## HENDERSON COUNTY TECHNICAL REVIEW COMMITTEE

**SUBJECT:** Revised Master and Development Plan for Preserve at Pinnacle/Preservation View at

Pinnacle (File #2007-M25)

#### **Henderson County Planning Department Staff Report**

Map B: Slopes

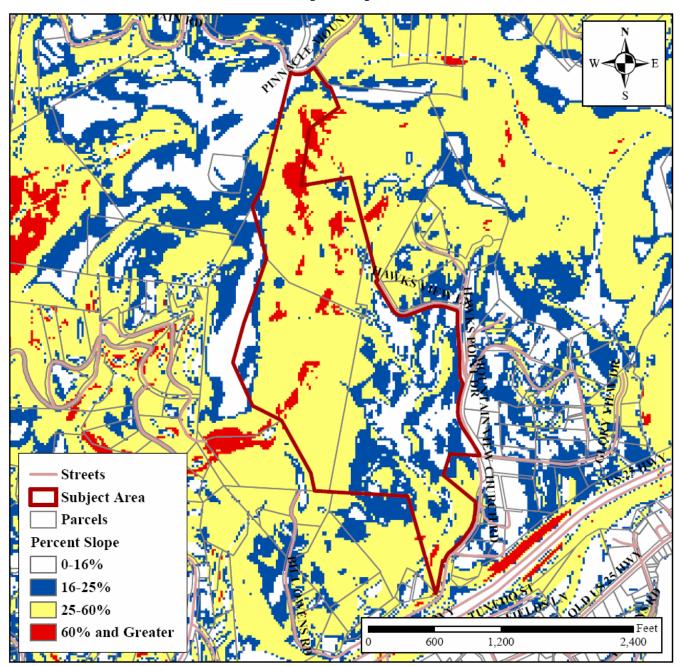
Conservation Area. The conservation area designation is applied to much of the project site, largely due to slope and a protected mountain ridge (See Map B: Slopes and Map C: Protected Mountain Ridges). Approximately 60.99% of the project site (approximately 70.11 acres) has slopes of 25-60% and approximately 5.14% of the project site (approximately 5.91 acres) has slopes in excess of 60%. According to the plan, the applicant is providing 22.50 acres of open space which is primarily identified in areas with slopes of 25% or greater (See Attachment 6, Revised Master and Development Plan). The CCP states that conservation lands "are intended to remain largely in their natural state, with only limited development," and further that "such areas should be targeted for protection through regulations and incentives" (2020 CCP, Pg. 134).

**Map C: Protected Mountain Ridges**

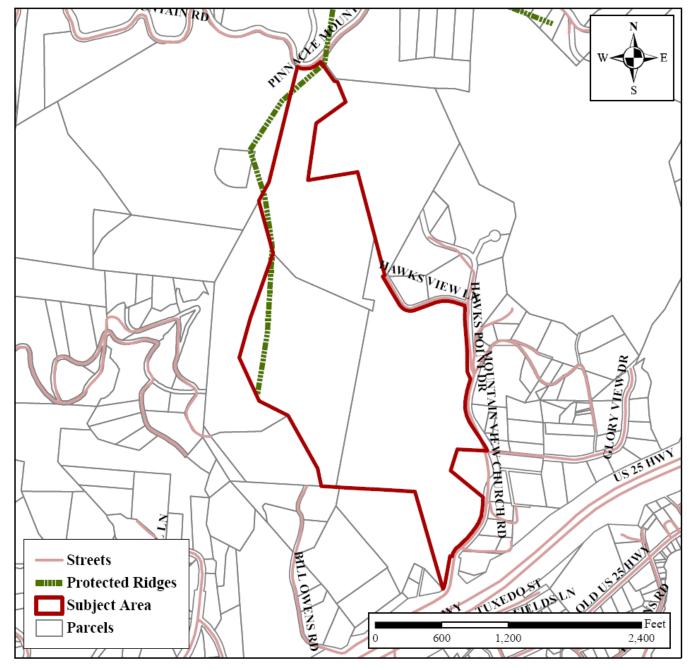
2. **Protected Mountain Ridges**. The project site appears to contain areas effected by the Mountain Ridge Protection Ordinance which states that the provisions of NCGS 113A-209 apply to all mountain ridges in Henderson County whose elevation is 500 feet or more above the adjacent valley floor (Map C: Protected Mountain Ridges). NCGS 113A-209 states that no county may authorize the construction of, and no person may construct, a tall building or structure on any protected mountain ridge. The definition of a tall building found in NCGS 113A-206 is any building with a vertical height of more than 40 feet measured from the top of the foundation and the uppermost point of the building. Additionally, where such foundation measured from the natural finished grade of the crest or the natural finished grade of the high side slope of a ridge exceeds three (3) feet, then such measurement in excess of three (3) feet shall be included in the 40-foot limitation provided that no such building protrudes at its uppermost point above the crest of

the ridge by more than 35 feet. The area of ridge under protection is defined as the elongated crest or series of crests at the apex or uppermost point of intersection between two (2) opposite slopes or sides of a mountain, and includes all land 100 feet below the elevation of any portion of such line or surface along the crest.

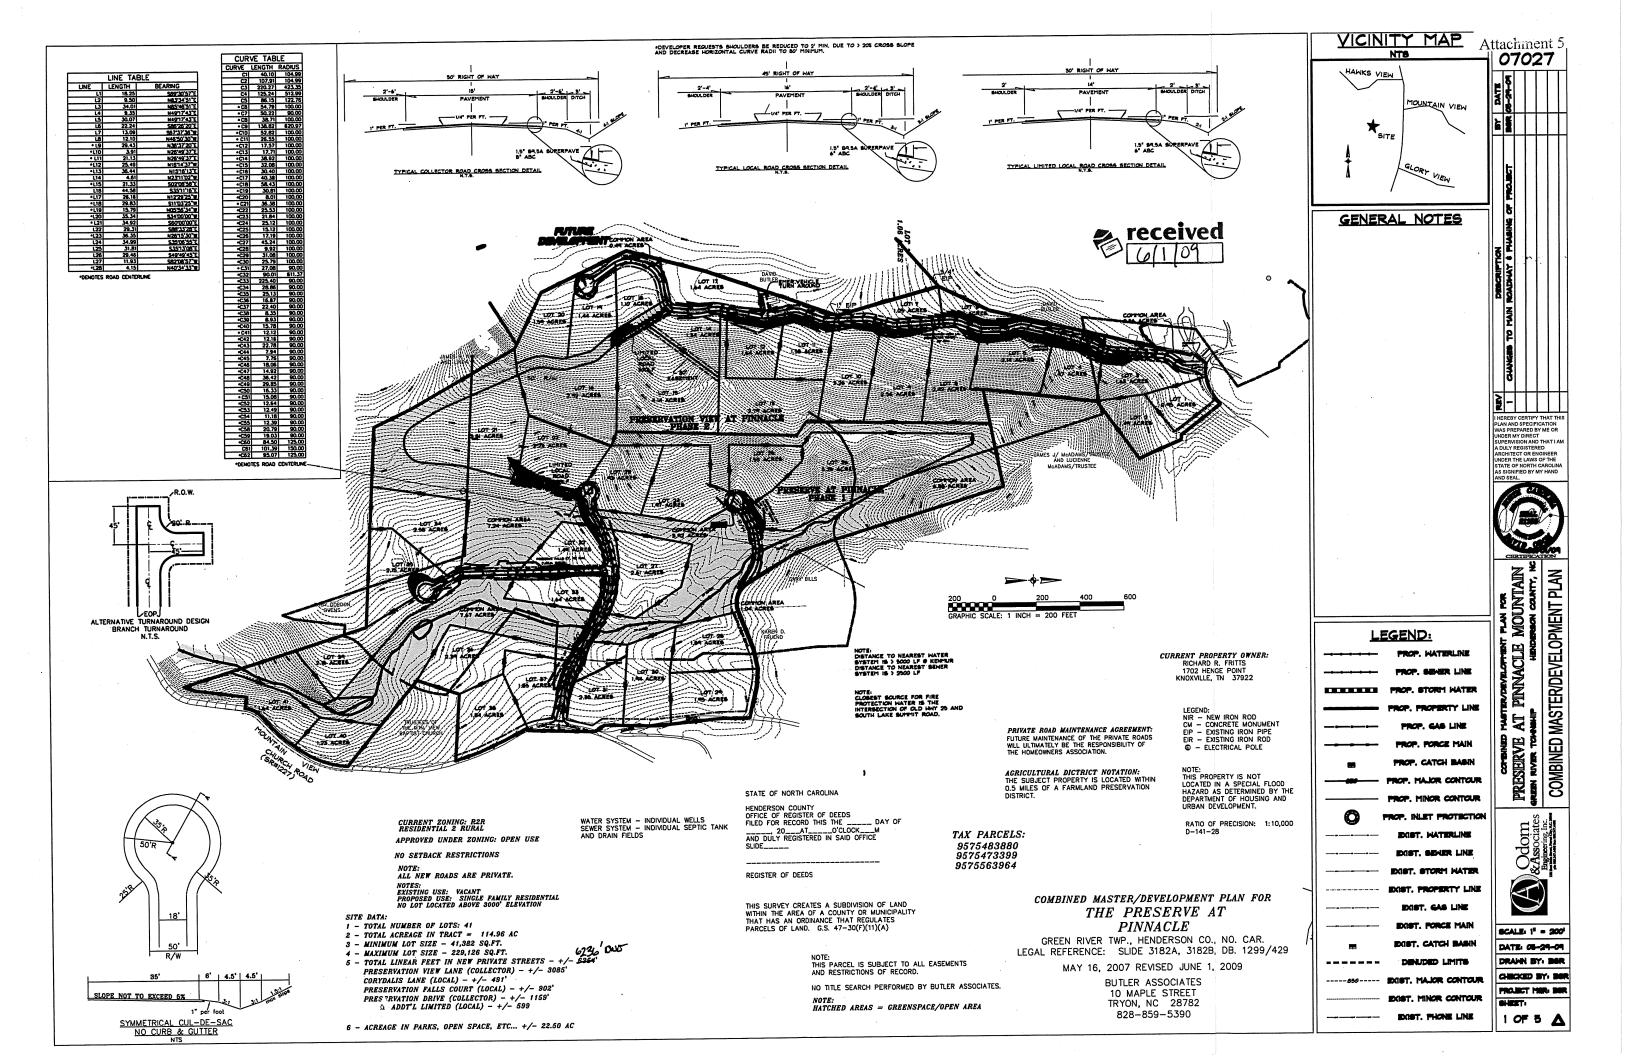
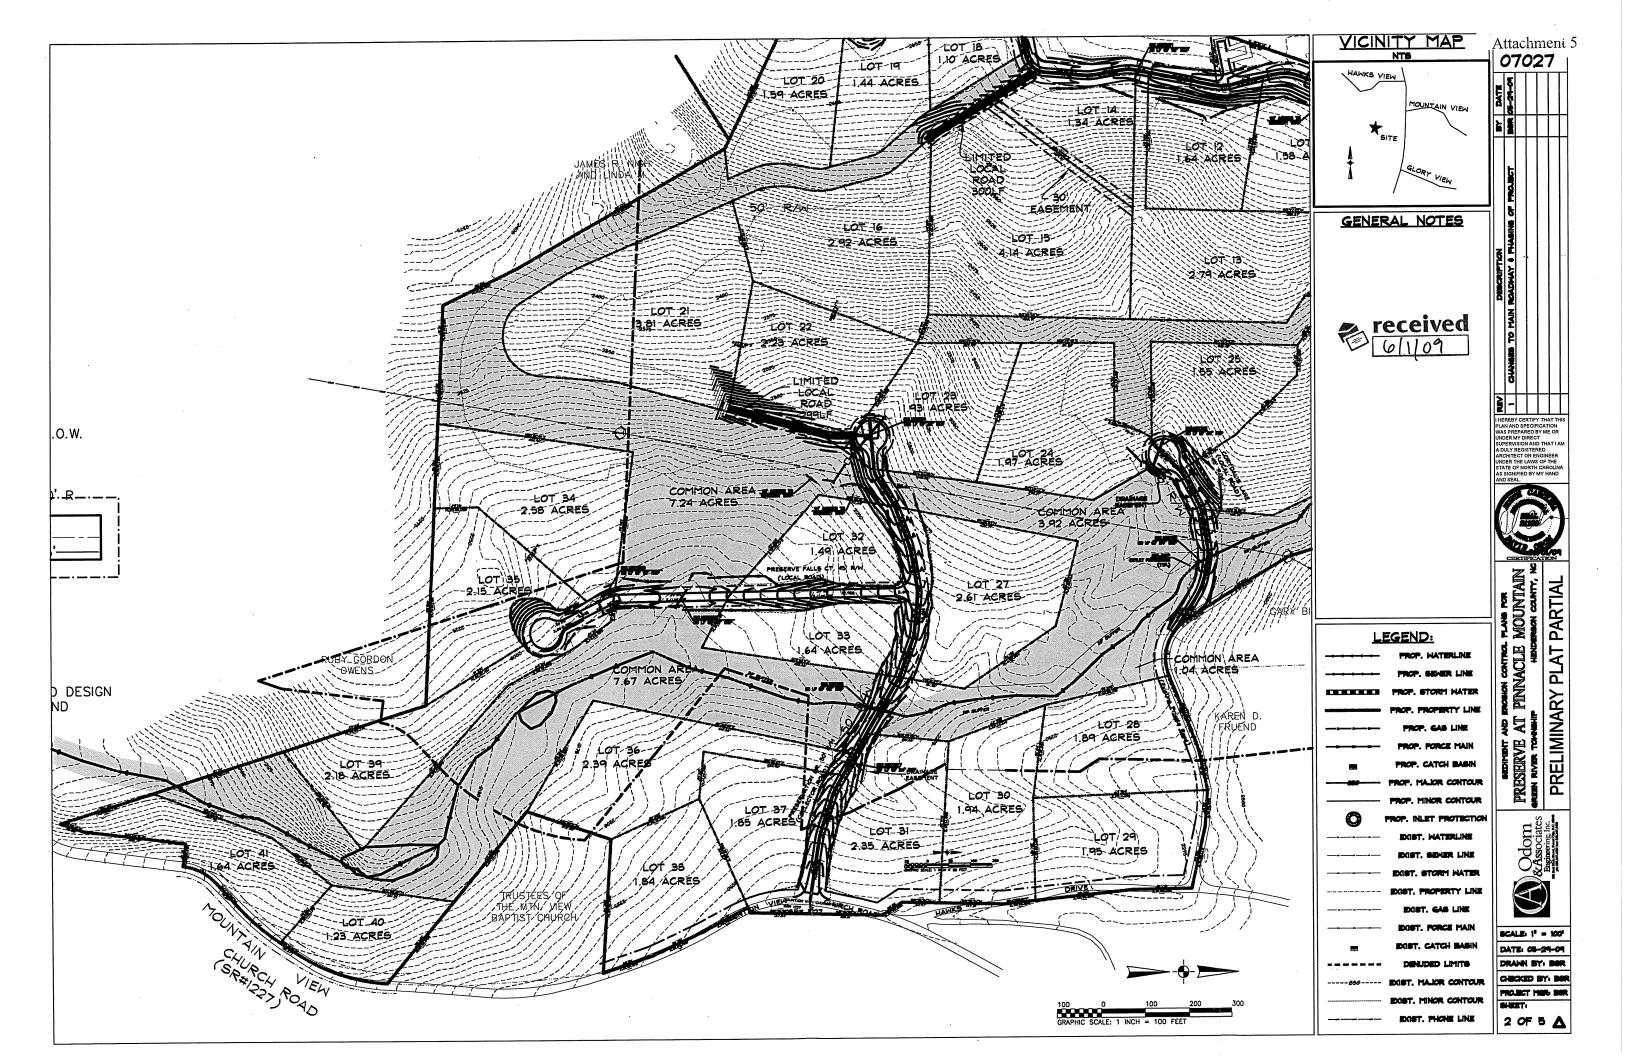
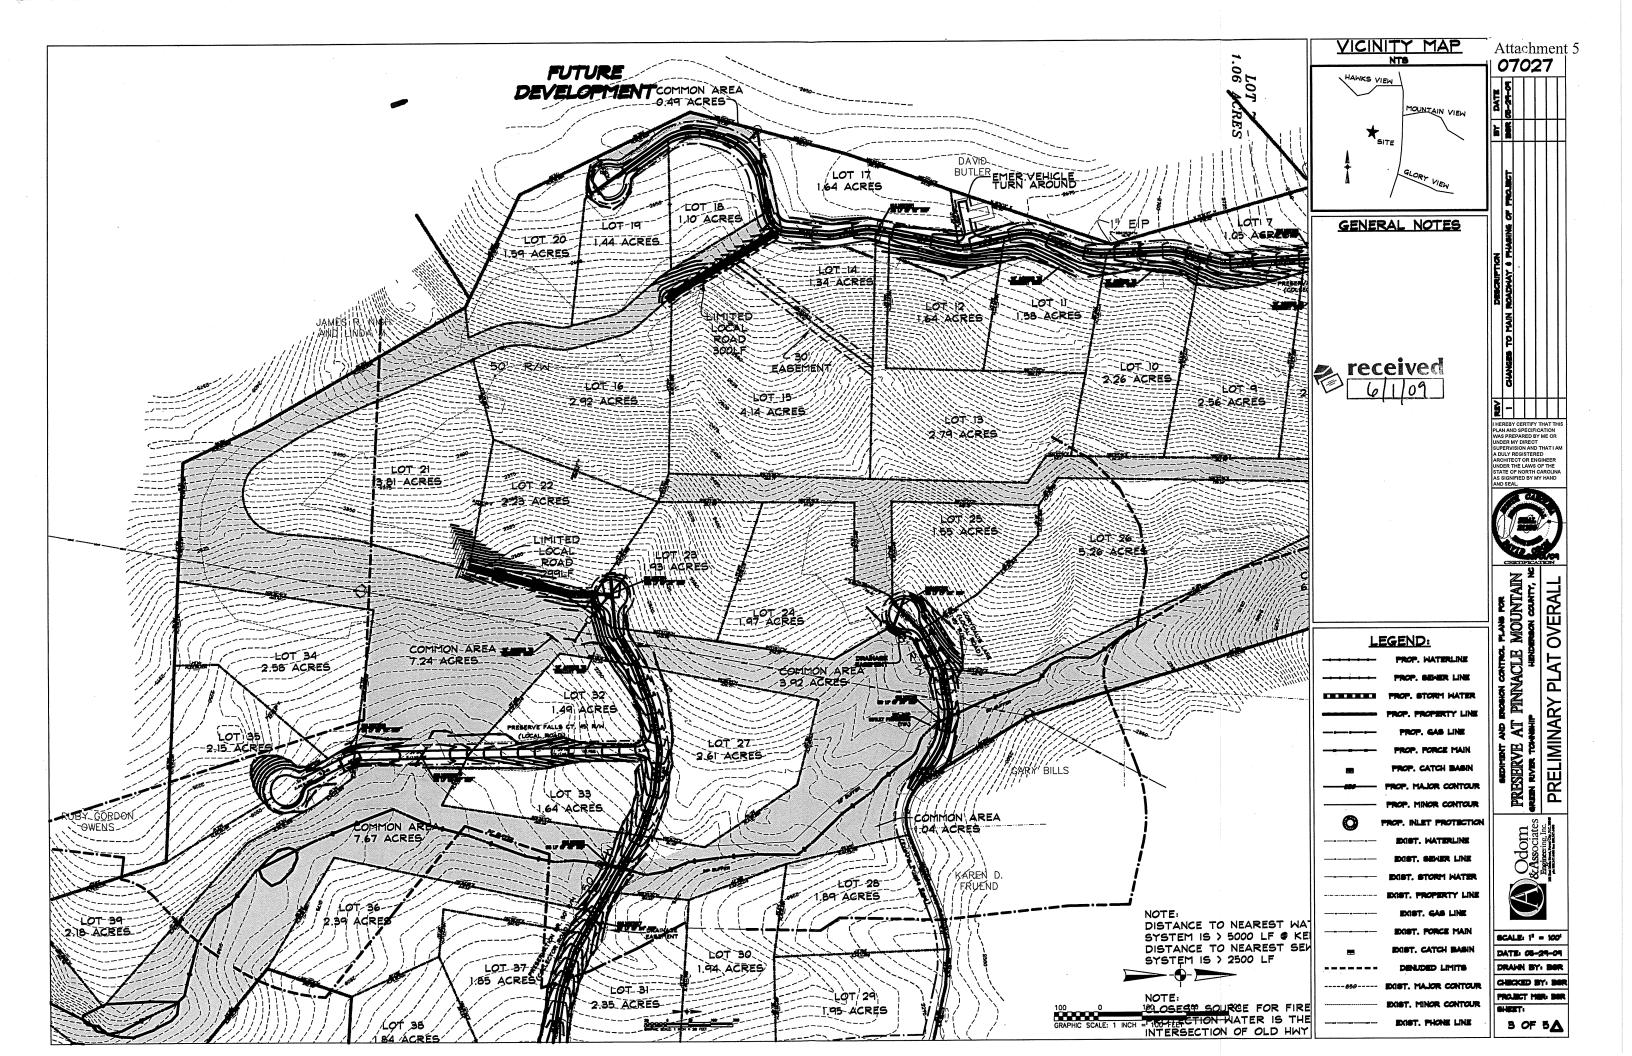
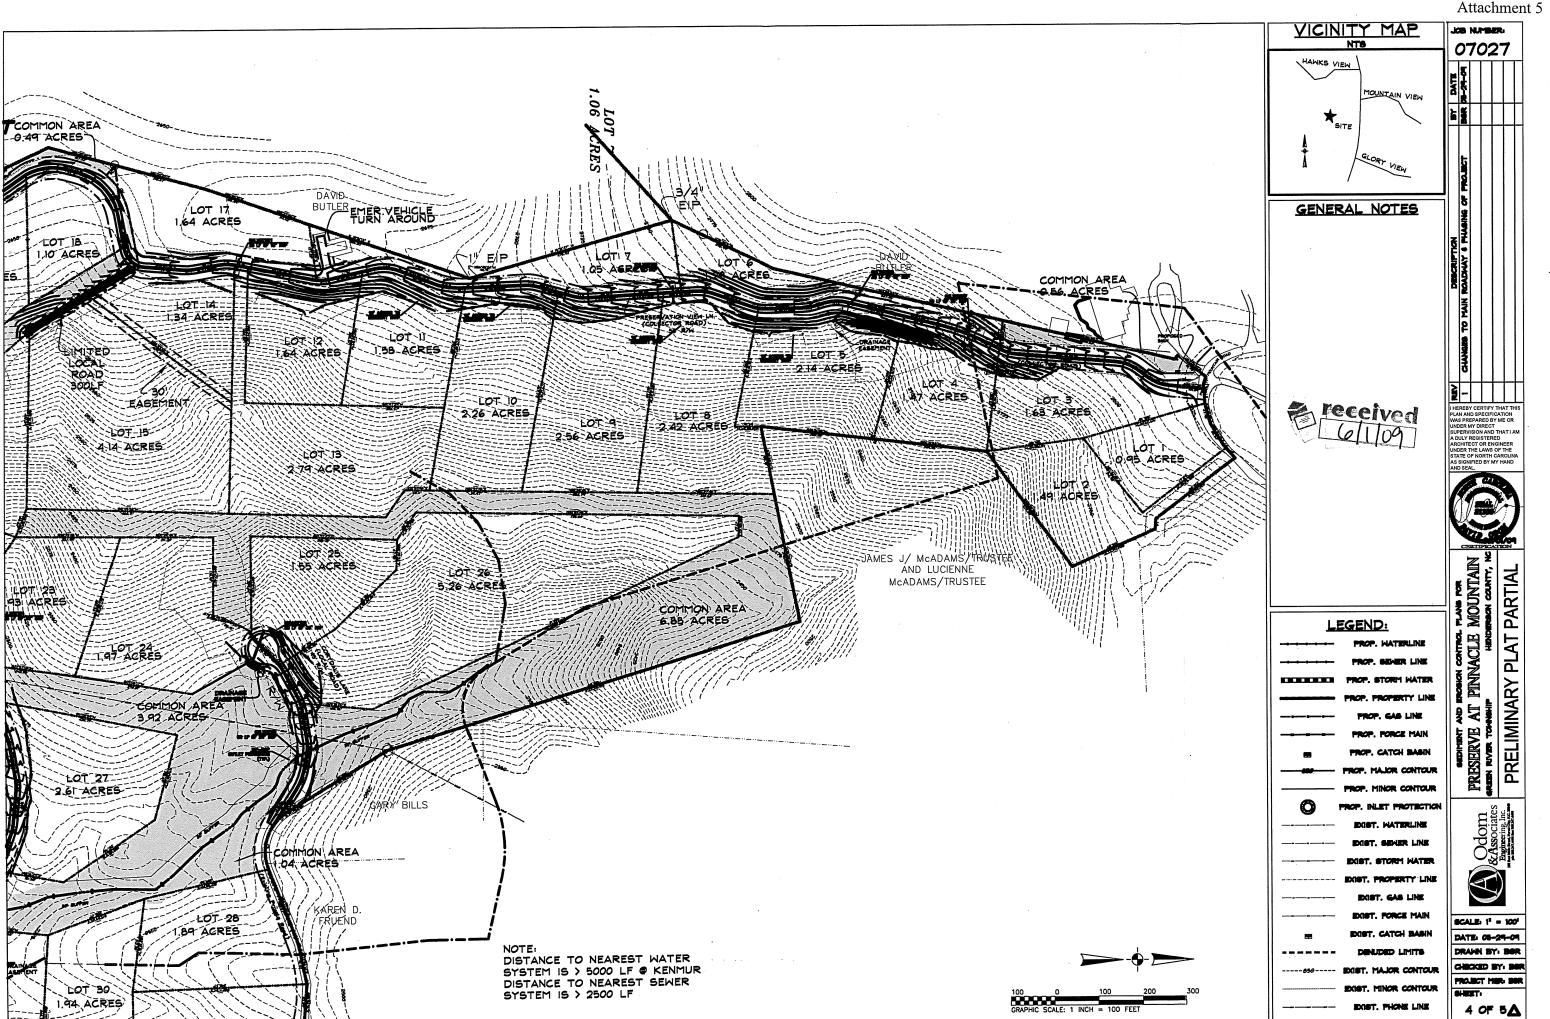
10. **Dead ends, culs-de-sac and turnarounds.** All roads or sections thereof with dead-ends or culs-de-sac should not exceed 2,500 feet in length. The Planning Board may require the installation of a partial turnaround along any road that exceeds 1,500 feet in length (HCSO §170-21H). Preservation View Lane is proposed to be 3,085 feet in length. The Applicant is proposing a turnaround within Lot 7 of the development because of the length of this segment of proposed former Preservation Drive. The Technical Review Committee may wish to recommend this proposed partial turnaround be required by the Planning Board.

- 1. The previously approved roadway shown as Preservation Drive (50' R/W) is now being shown as two separate roadways (Preservation Drive and Preservation View Lane). The purpose behind this was to drastically eliminate the disturbed area (both cut & fill) to connect the once proposed road along the northwestern corner of the property. Proposing this has actually allowed the owner to Phase the project "Phase I Preserve at Pinnacle & Phase II Preservation View at Pinnacle.

- 2. Three (3) local limited roads have been added to the preliminary plat for access to individual properties.
- 3. An emergency vehicle turnaround has been shown along Preservation View Lane due to the length.
